## *DR's for Serial # QXFA202*

# MAGNET DISREPAANCY REPORT

Part No: F10030927		Rev	Traveler No.: AUP-100	Rev: A
Part Name: QXFA Coil Winding & Curing			Traveler OP No.: 230	
Qty: 1	Ser. No./Lot No.: QXFA202		Operation: Respooling	
Initiator: H. Hocker		Life No.: 22131	Date: 9-11-18	
Type of Problem: (Check) Mechanical      Electrical      Other <input checked="" type="checkbox"/>				
Description			Disposition	CE
Continue on reverse side if required			RWK, RPR, UAI, SCP	DQAR
During respooling, a raised strands were detected on the side facing down (the side which would face the coil island). The raised strands continued for most of the length of the conductor.			UAI	<i>[Signature]</i>
Instructions: Continue on additional sheets if required			Name	Life #
USE AS IS - MONITOR AND NOTE CABLE STABILITY DURING COIL WINDING				
Reason for Discrepancy:				
UNSTABLE CABLE				
Corrective Action:				
REPORT ISSUE TO CABLE FAB GROUP - DONE 10/15/18				
Report reviewed by CE <i>[Signature]</i>			Date	<u>9/28/18</u>

DR AM-113  
2/2

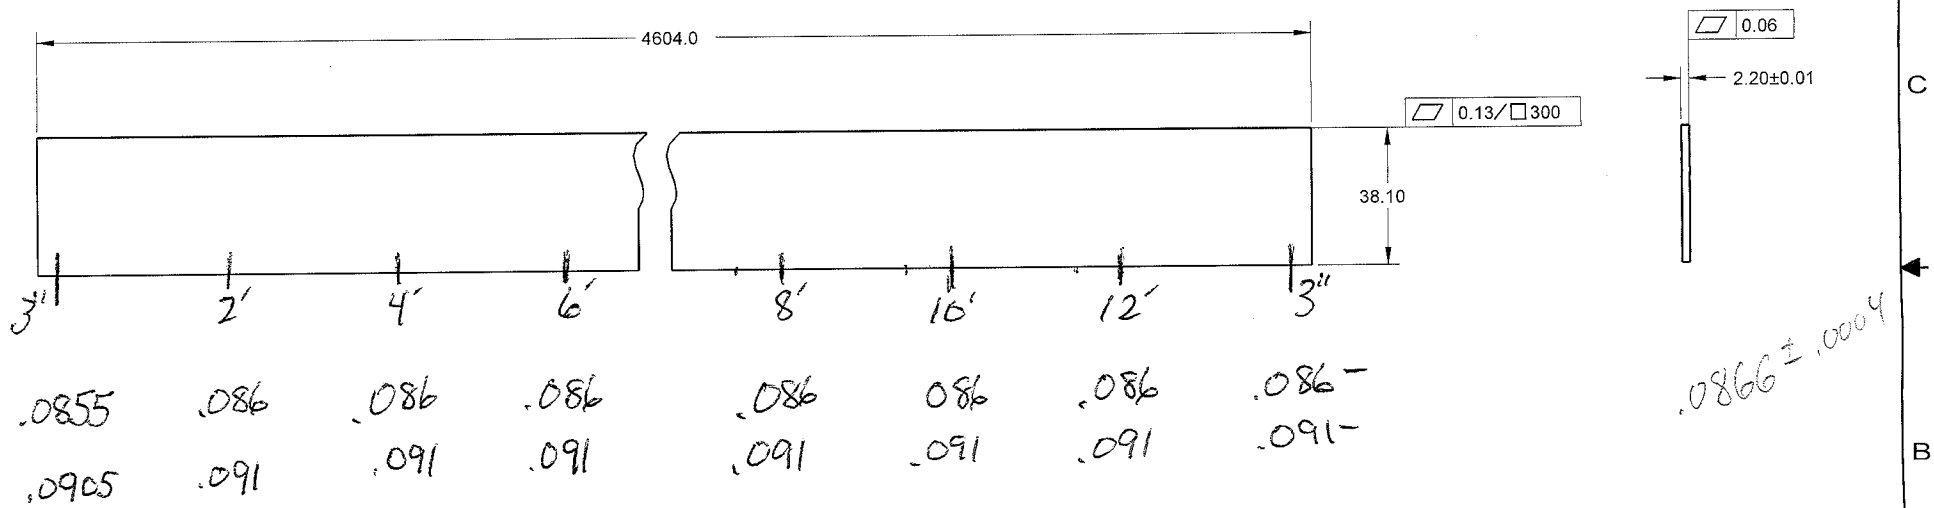
Description <small>Continue on reverse side if required</small>	Disposition	CE	DQAR
	<small>RWK, RPR, UAI, SCP</small>		
<u>One midplane shim was found to be .005 thicker than the other one. .091 vs. .086.</u>			
<u>Discrepancy was found to be consistent down the full length of shim, as shown on attached sheet.</u>	<u>RWK</u>	<u>JA</u>	<u>CB</u>

Instructions: <small>Continue on additional sheets if required</small>	Name	Life #	Date
<u>MARK EACH SHIM WITH ACTUAL THICKNESS.</u>			
<u>OMIT THE LAYER OF .005" MYLAR FROM THE MIDPLANE WHERE THE OVERSIZE SHIM IS INSTALLED.</u>	<u>T. Levine</u>	<u>21627</u>	<u>12/7/18</u>

Corrective Action: FERMI TO PROVIDE UPDATED SHIMS
